**HISTORIC DESIGN REVIEW COMMISSION
COMPLIANCE AND TECHNICAL ADVISORY BOARD**

HDRC CASE NO: 2024-303
ADDRESS: 275 W MANDALAY DR
LEGAL DESCRIPTION: NCB 9009 BLK 5 LOT 88 0.17 AC (275 W MANDALAY SUBD)
ZONING: R-4, H
CITY COUNCIL DIST.: 1
DISTRICT: Olmos Park Terrace Historic District
APPLICANT: Philip Bates/BATES TRUST
OWNER: Philip Bates/BATES TRUST
TYPE OF WORK: Window replacement
APPLICATION RECEIVED: August 08, 2024
60-DAY REVIEW: October 07, 2024
CASE MANAGER: Caitlin Brown

The applicant is requesting a Certificate of Appropriateness for approval to: Replace eleven (11) historic divided-lite steel casement window units AND one (1) non-historic window unit with a vinyl window product.

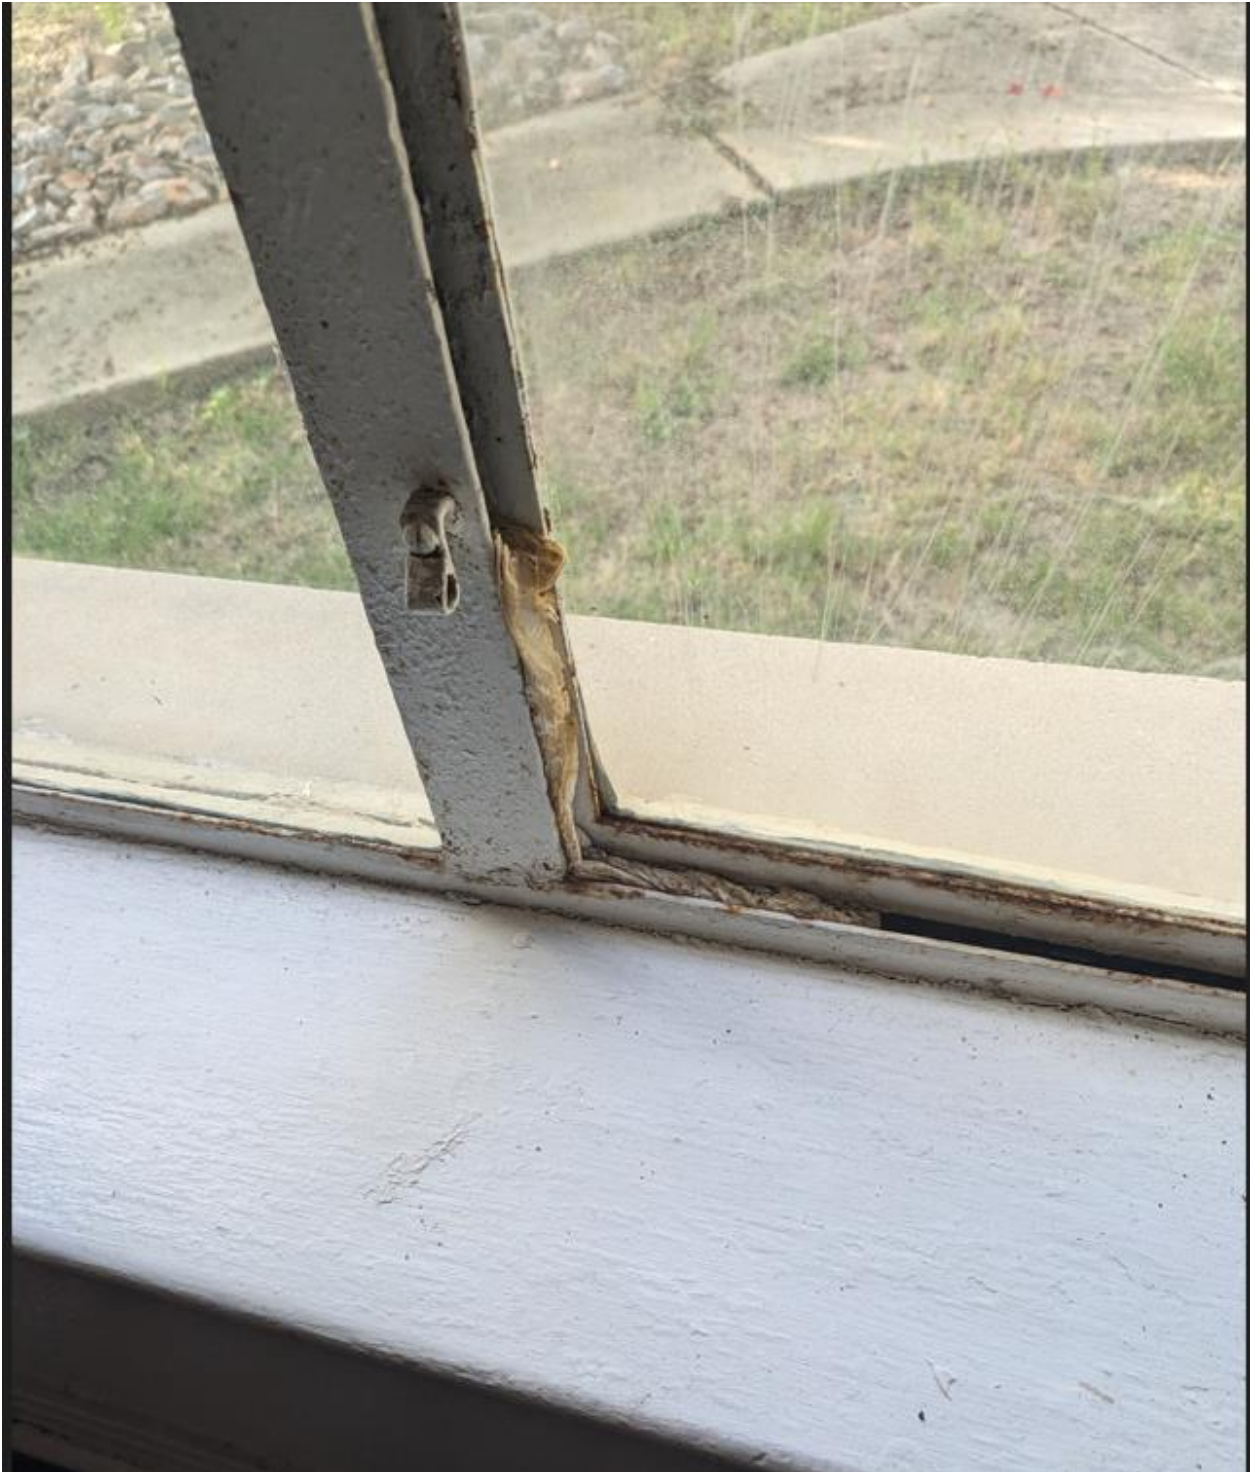
- WINDOW REPLACEMENT** - The applicant has requested to replace twelve (12) windows, eleven (11) of which are historic. One (1) window on the rear façade has been previously replaced with a fixed pane yet maintains historic steel members at the top of the window. The applicant has proposed to replace all windows with a vinyl window product. The Historic Design Guidelines state that replacement windows must match the appearance, materials, size, design, proportion, and profile of the original historic windows.

- SITE VISIT** - OHP Staff conducted a site visit on 9/11/24 to inspect the condition of the existing windows. It is evident that the windows have not had regular maintenance for several years and have been poorly repaired. These factors have rendered several windows inoperable and prone to water infiltration furthering their worsening condition. Most windows will require putty, caulking, paint and rust removal in addition to hardware and glazing replacement.

Staff does not recommend approval of window replacement with a vinyl window product based on findings a through c. Staff recommends that the windows either be repaired or replaced with a product that maintains a similar appearance and profile (aluminum or steel casement.)

- Install 1 over 1 fully wood or aluminum clad wood windows or 6 over 6 fully wood or aluminum clad wood windows with true divided lights featuring real muntins. These windows must meet the Standard Specifications for Original Wood Window Replacement.
